Access Compliance Report

Public Rights-of-Way

Intersection ID: 30257	Main Street: BRADEN_DR	Cross Street: GOOSEDOWN_CT	Location: NE
ADA ID: CC387C5AF5DC	Ramp Type: PerpDiag	Initial Pass/Fail: Fail	Overall Compliance: No
		Severity Score: 25

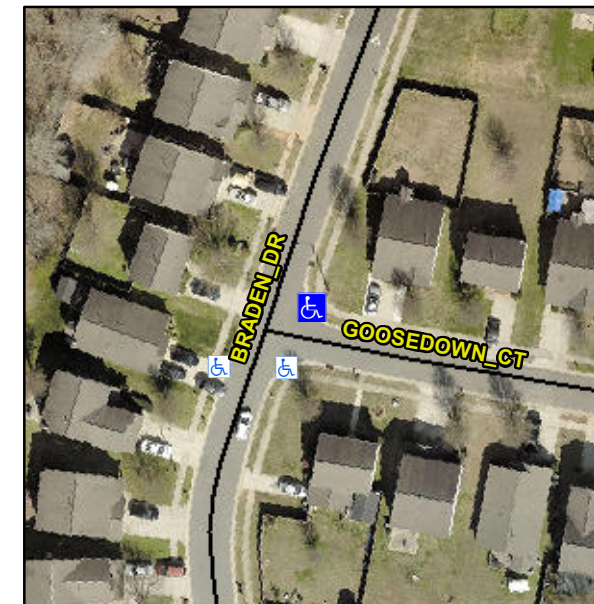
Not Found, R304.5.3

Compliance	Description	Data	Compliance	Description	Data
N/A	Ramp Length (in)	53.0	Yes	Ramp Slope (%)	6.2
Yes	Ramp Width (in)	54.0	No	Ramp XSlope (%)	7.1
N/A	Flare Type LT	N/A	N/A	Flare Type RT	N/A
N/A	Flare Slope LT (%)	N/A	N/A	Flare Slope RT (%)	N/A
N/A	Flare Traversable LT?	N/A	N/A	Flare Traversable RT?	N/A
N/A	Landing Length (in)	N/A	N/A	DWS Provided?	N/A
N/A	Landing Width (in)	N/A	N/A	DWS Contrast?	N/A
N/A	Landing Slope (%)	N/A	N/A	DWS Length (in)	N/A
N/A	Landing X Slope (%)	N/A	N/A	DWS Full Width?	N/A
N/A	Landing Curb? (Y/N)	N/A	N/A	DWS Offset (in)	N/A
N/A	Shared Landing?	N/A			
N/A	Gutter Ponding?	N/A	N/A	Gutter Slope (%)	N/A
N/A	Gutter Lip Ht (in)	N/A	N/A	Gutter X Slope (%)	N/A
N/A	Painted X Walk1?	No	N/A	Painted X Walk2?	No
	X Walk 1 Direction	To NW		X Walk 2 Direction	To SW
N/A	X Walk 1 Width (in)	N/A	N/A	X Walk 2 Width (in)	N/A
	X Walk 1 Slope (%)	0.9		X Walk 2 Slope (%)	1.5
	X Walk 1 X Slope (%)	2.6		X Walk 2 X Slope (%)	3.5

Remove & Replace Curb Ramp With Two New Directional Ramps or Equivalent.
